CONSTRUCTION OF THE KIGONGO – BUSISI BRIDGE (3,200 M) AND ITS ASSOCIATED APPROACH ROADS (1.66 KM), LOCATED IN MWANZA, TENDER NO. AE/001/2018-19/HQ/W/101

Clarification No. 2 to the Tender Documents

Date: 25th February 2019

GUARDRAIL ERECTION DETAILS
 DRAWING No: TOA/05/7-005
 SCALE: AS SHOWN
 DATE: 21 FEBRUARY, 2019

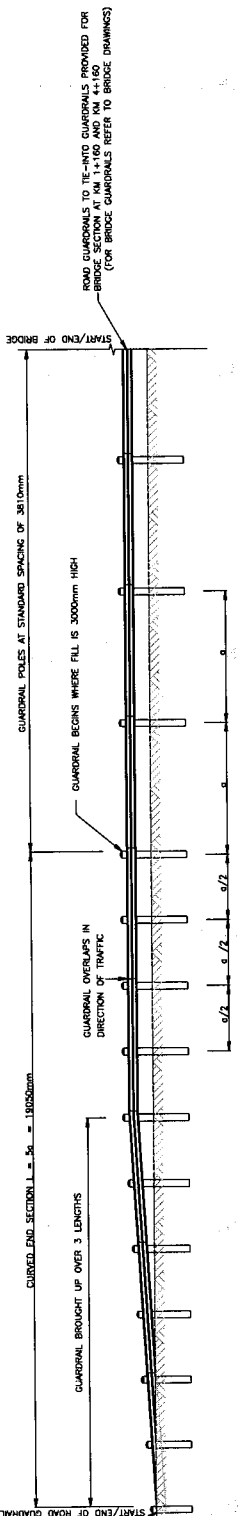
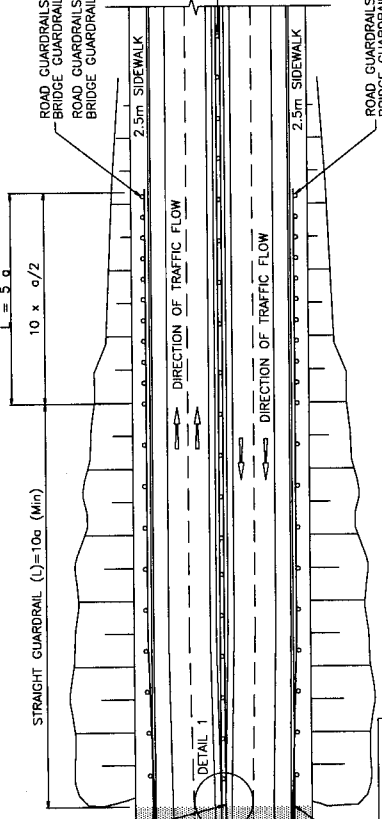
BOQ SECTION 5200: GUARDRAILS,
Item 52.04: End Units.

(i) Please clarify whether the end units are at the ends of the bridge on in the intersections.

(ii) Kindly mention the drawing for this item.

T004-DS-ROADS: BOOK OF DRAWINGS

T004/DS/Y-005: Positioning detail at bridge

Please clarify what the 'End Block' refer to, as there are no details for this part of the bridge.

(i) The location of the end units is at the end of bridge on the median.

*(ii) Refer to drawings T004/DS/C-001 and Revision 02 of drawing T004/DS/Y-005 – Refer **Appendix 1 of Clarification No. 2** attached herewith. Drawing also issued in softcopy – pdf format.*

Refer response to Question No. 27.
